**Amendments to the Drawings:**

# ANNOTATED SHEET SHOWING CHANGES

Serial No. 09/944,233  
Filed August 30, 2001  
Attorney Docket No. 3161.3US  
Sheet 2 of 15  
Contact: K. Weber Powell  
(801) 532-1922

**Fig. 5**

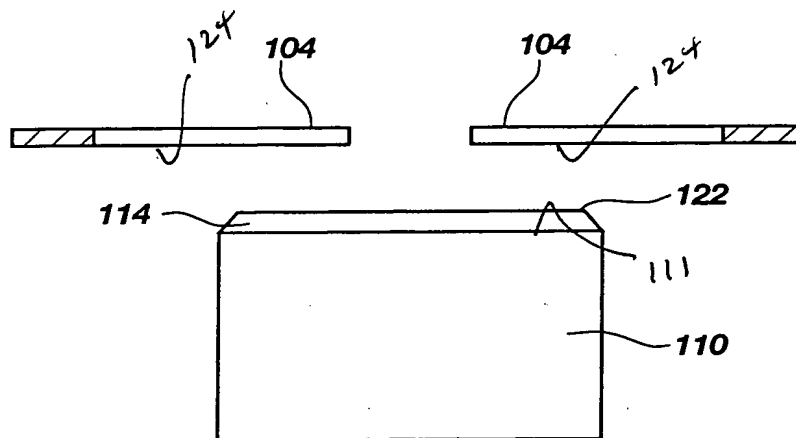
Specifically, FIG. 5 has been revised to add the reference numerals --124-- (two occurrences) and --111-- with appropriate lead lines; FIG. 6 has been revised to add the reference numerals --124-- (two occurrences) and --111-- with appropriate lead lines; and FIG. 7 has been revised to add the reference numeral --111-- with appropriate lead line. No new matter has been added.
